Re: Palomas Peak Ph. 2 Office Development 8300 Palomas Ave. NE 30-Day Temporary Certificate of Occupancy Transportation Development Final Inspection Engineer's Stamp dated 2-12-21 (D19-D031) Certification dated 3-30-22

Re: Palomas Peak 8300 Palomas Ave. NE Traffic Circulation Layout Architect's Stamp date 01/15/2021 and 2/12/2021 (D19D031)

AS101a

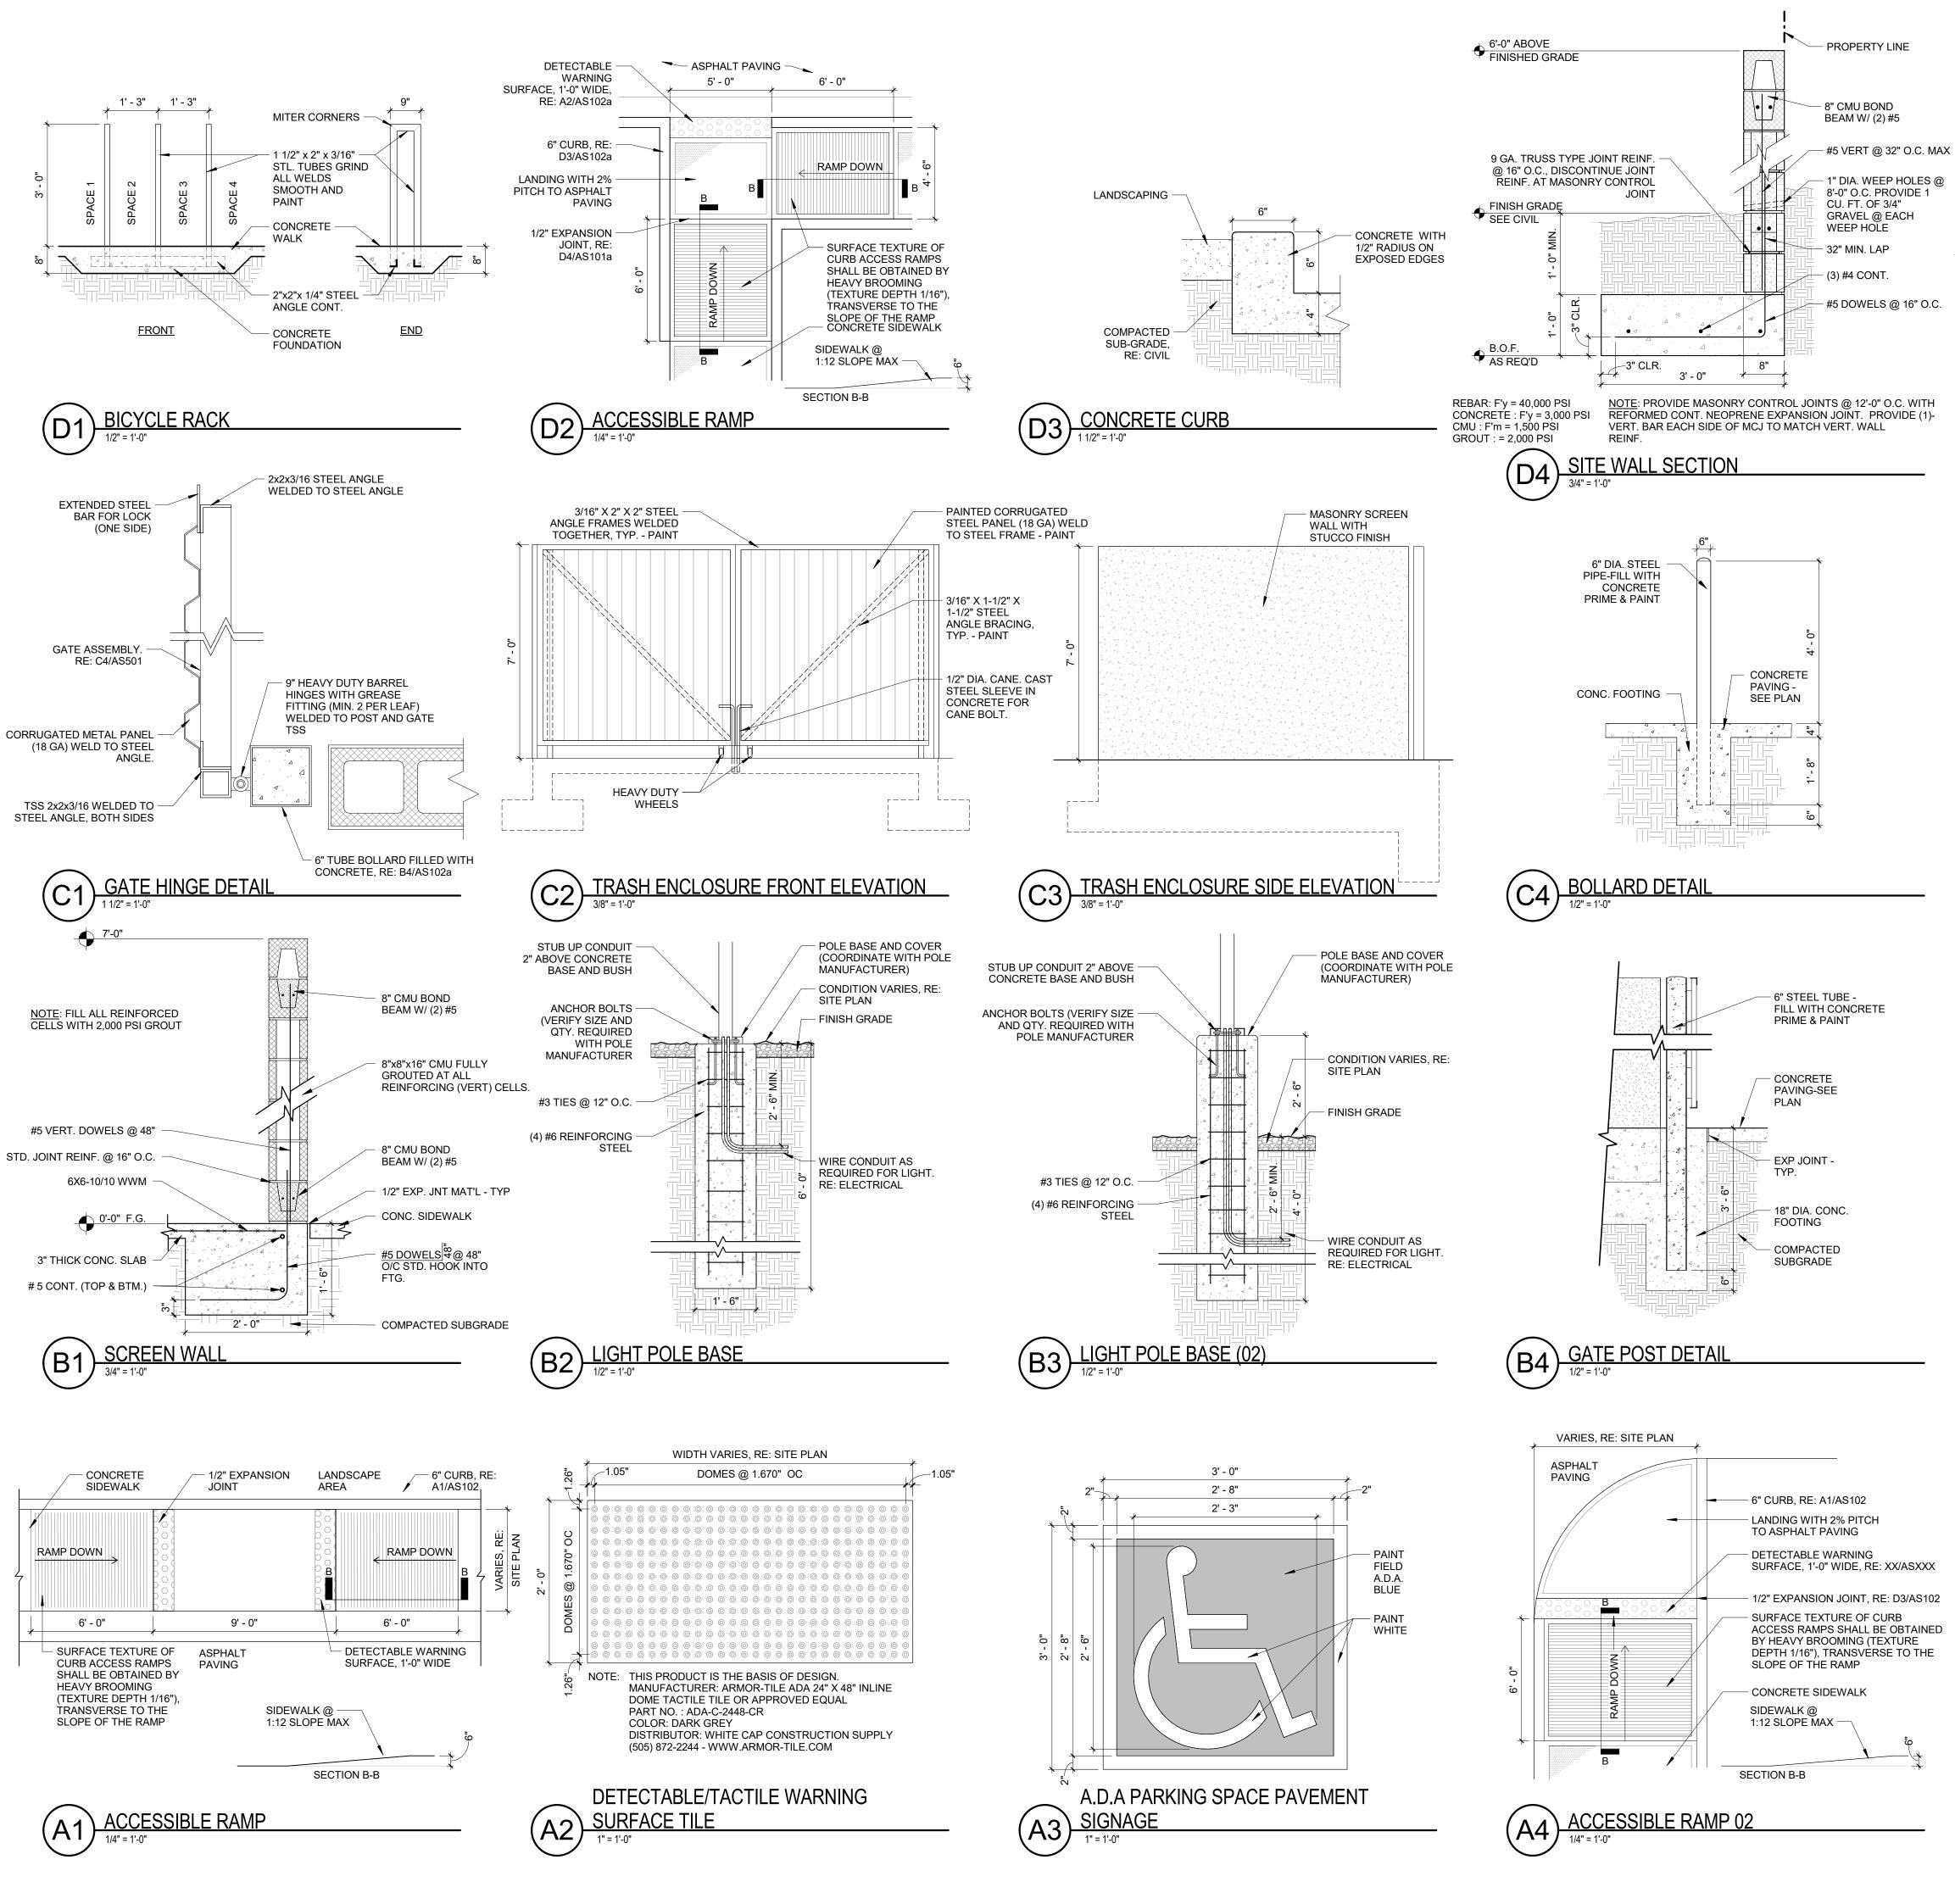
• There is a new ramp on the northside of the building, please red mark the approved TCL (add a key note for this ramp).

• Paint the curb that located at the northeast side of the driveway entrance with yellow. Just the segment that parallel with the ADA ramp, for tripping hazard issue.
